From : Kevin Carroll <kev_scout@hotmail.com>
Sent : Sunday, October 23, 2005 2:03 AM
To : kev_scout@hotmail.com
Subject : Permit Application

APPLICATION FOR PERMITS

From : Kevin Carroll <kev_scout@hotmail.com>
Sent : Sunday, October 23, 2005 2:01 AM
To : building@springdale.org
CC : kev_scout@hotmail.com
Subject : Permit Application Supplemental Info

Re: Permit Application – 658 Cloverdale Avenue, Springdale OH
Request for Revisions

DRAWING 2
Patio Roof Dimensions and Location:
~37' long by 15'6" deep
~42'8" from North (rear) property line
~44'11" from East property line
~15' from West property line

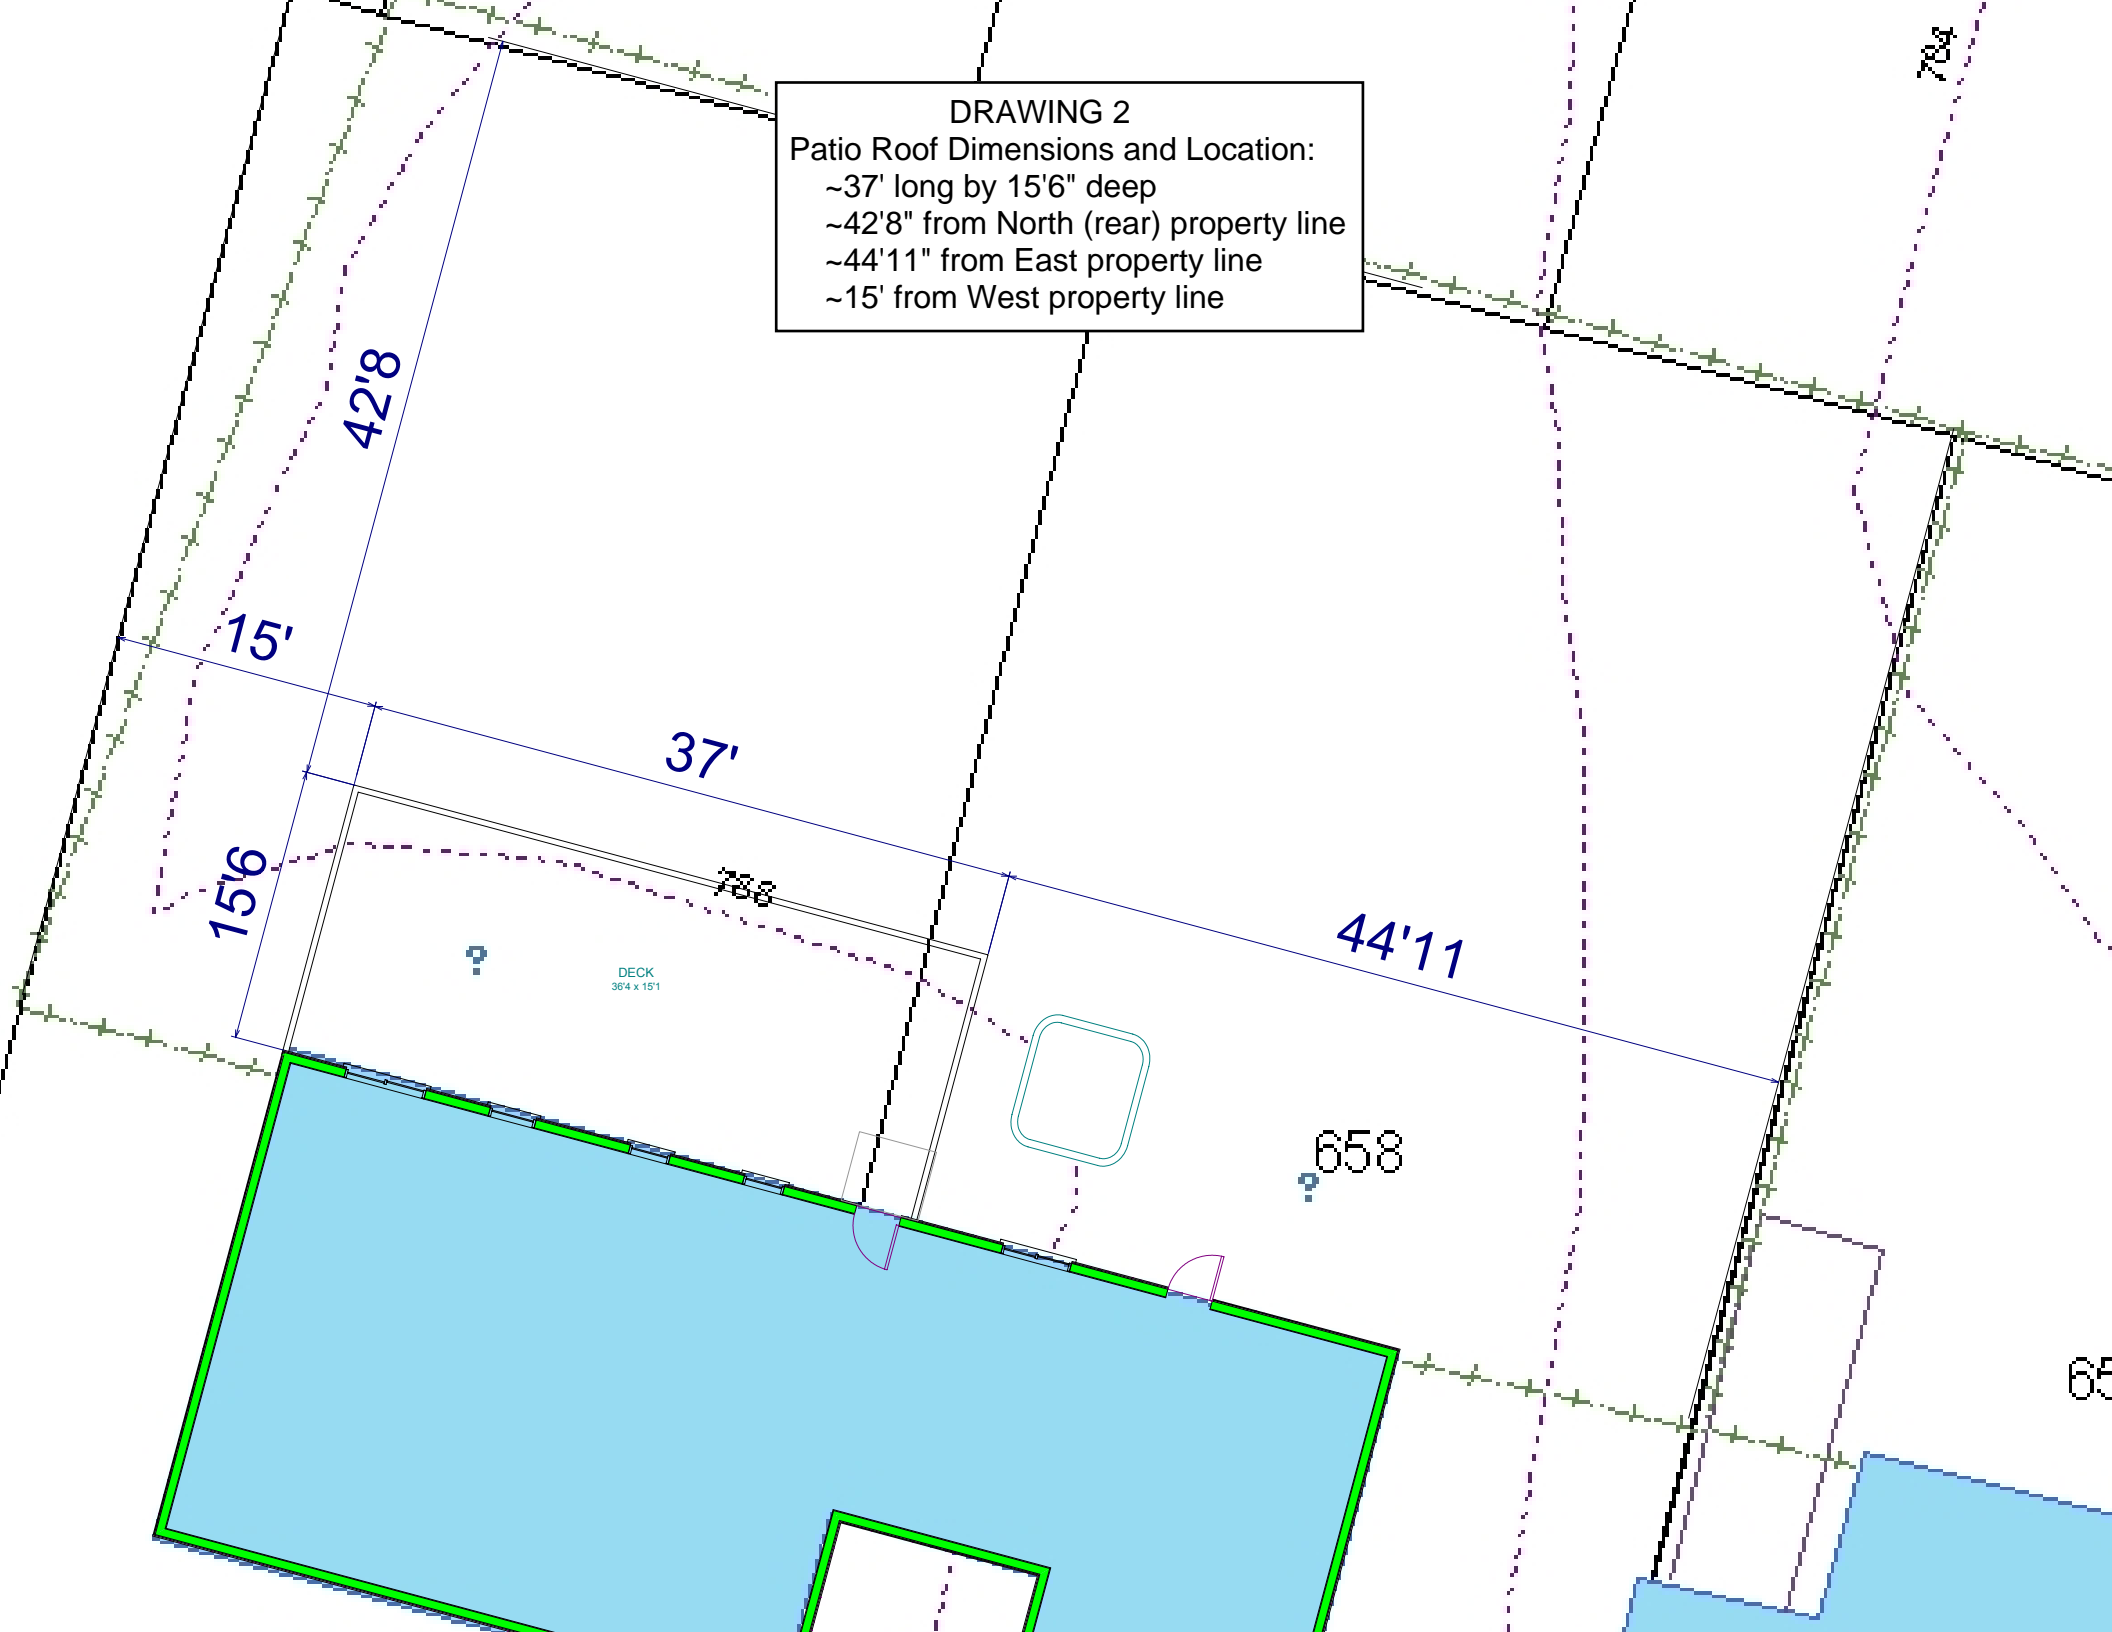
1. "Submit site plan showing distance to property lines."

This was attached previously as "Drawing 2". I have edited the document with some corrections/clarifications. First, I corrected the misspelling of "North". Second, I added red lines to clarify the beginning and end of the dimension lines. Finally, I changed the color of the dimension text to make it more obvious. Please let me know if it was missing any details.

DRAWING 5
"Floor Plan"

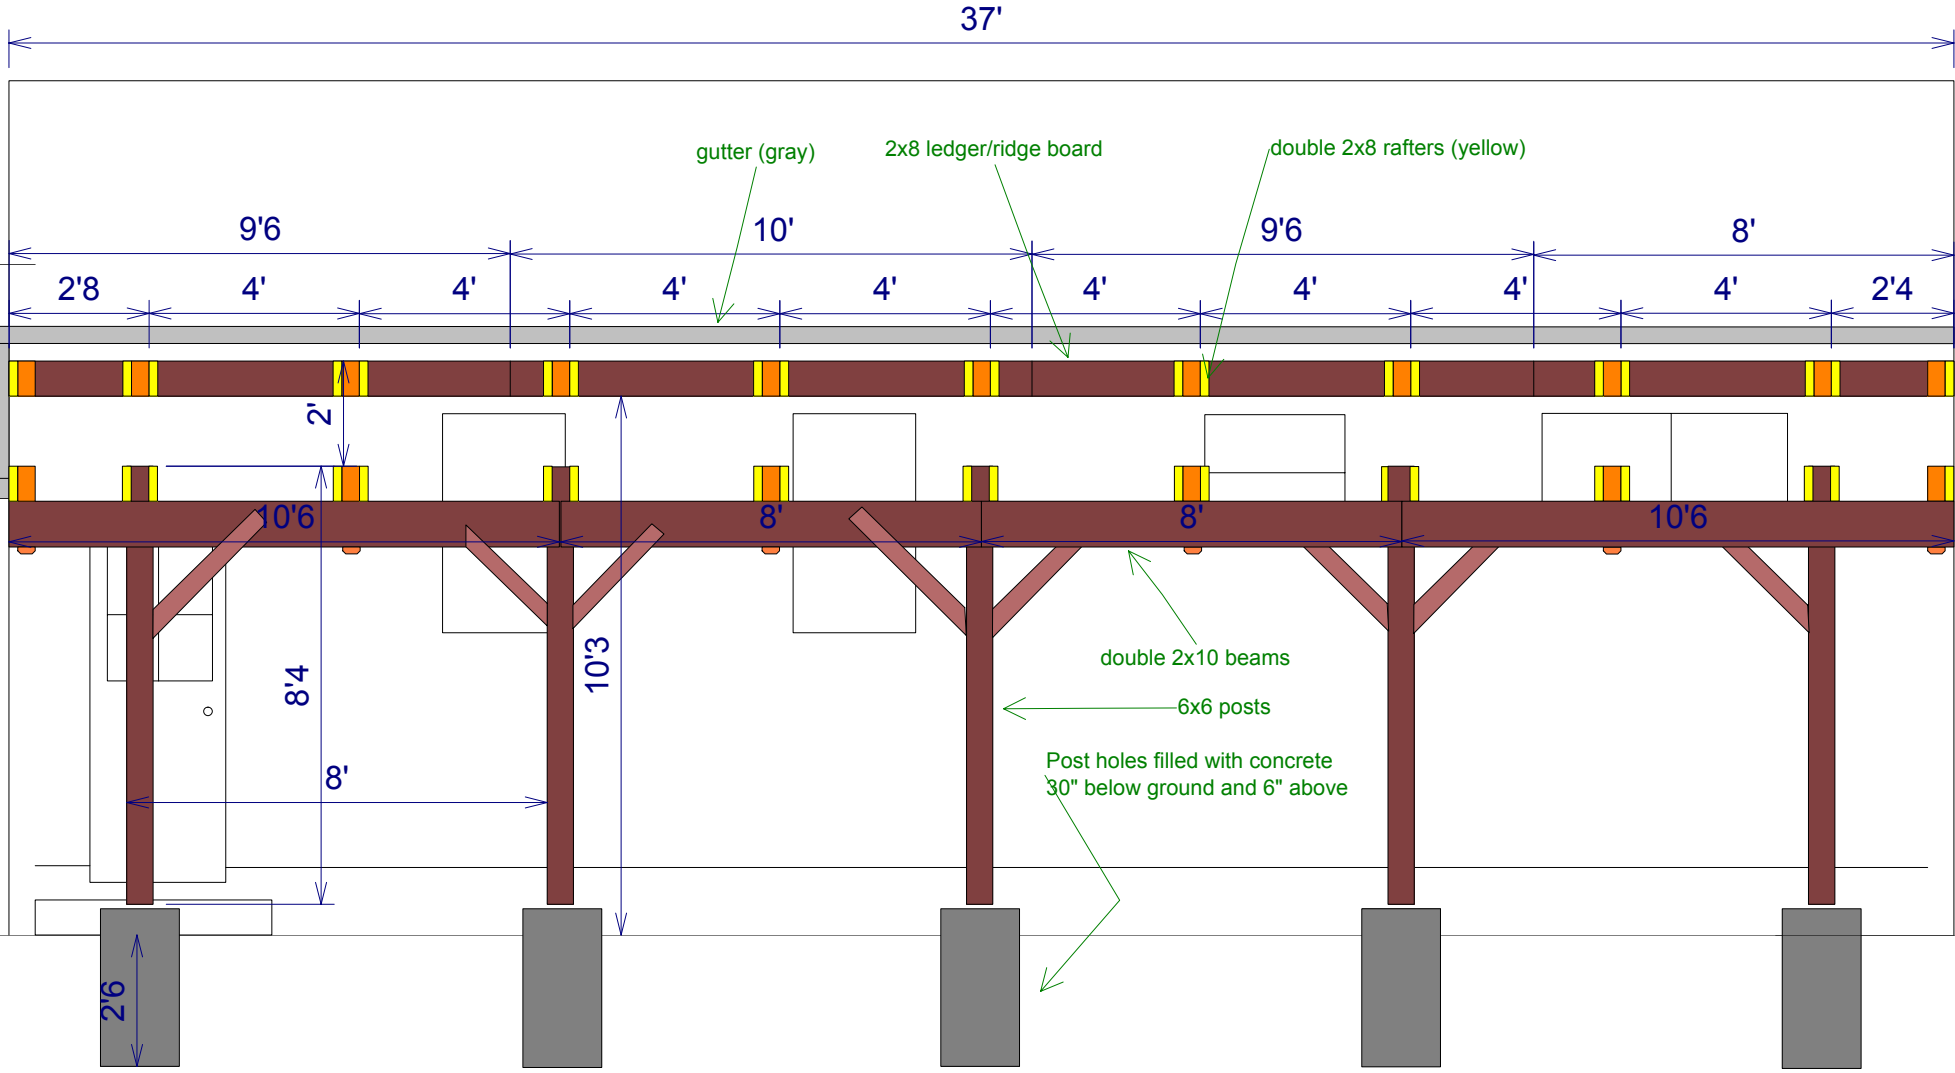
2. "Submit floor plan showing posts with dimensions."

All posts are 6" x 6" and are 12' from the house on 8' or 10' spacing. The only 4x4s used are the 12" spacers. Both can be seen in "Drawing 3". I have included an additional drawing showing the detailed "floor plan". It is attached as "Drawing 5".

DRAWING 6
Ledger, Post, and Beam Details

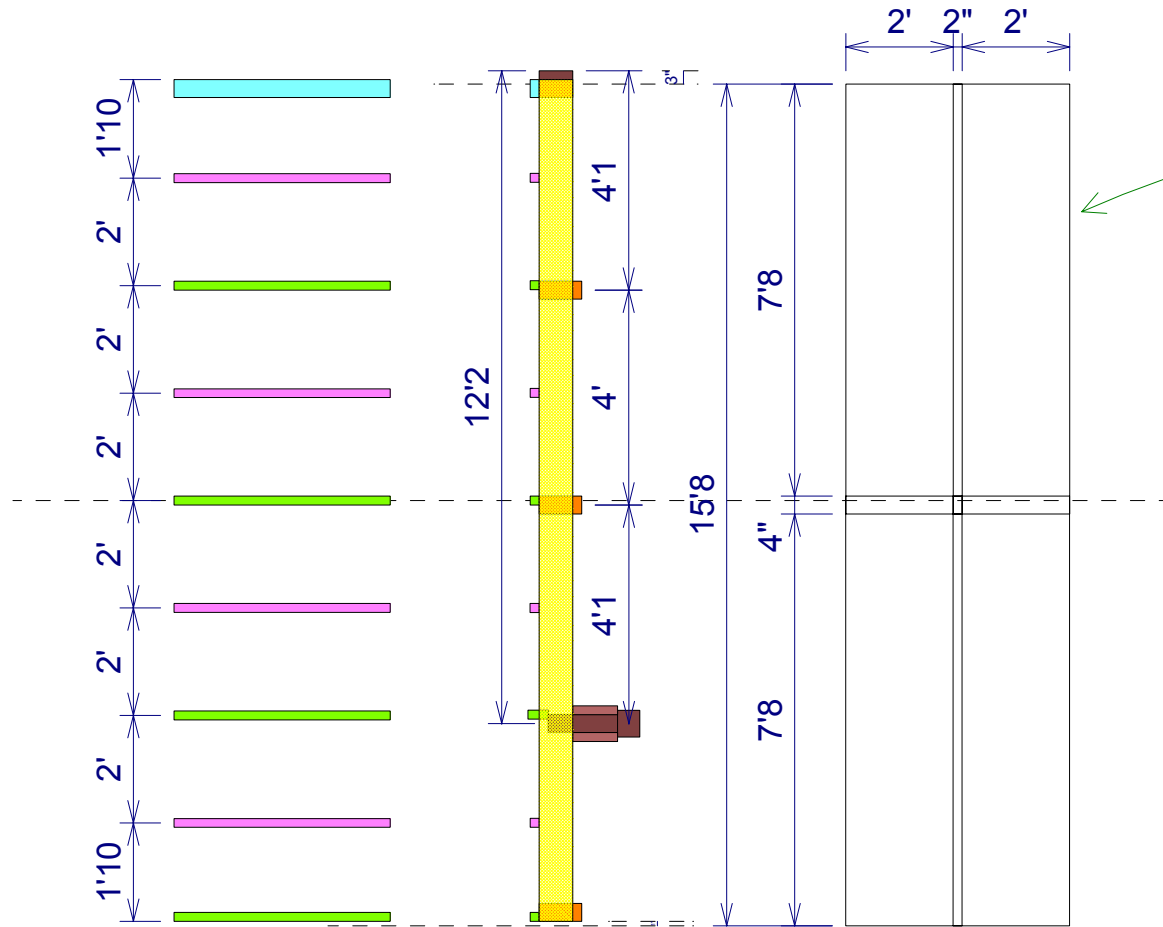
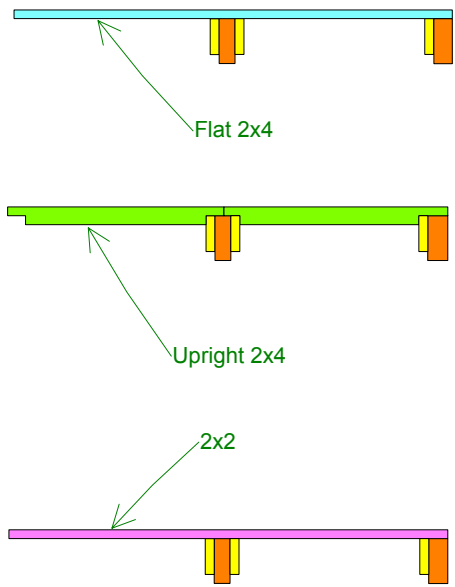
3. "Submit detail showing connection to house."

The top panel of siding under the gutter will be removed. A 2" x 8" ledger/ridge board will be attached in its place using lag bolts. Suntuf Wall Connectors will be used for head flashing at the wall (see "Roofing Material Info 3b"). I have also attached a new drawing from the front showing the ledger/rafter details ("Drawing 6").
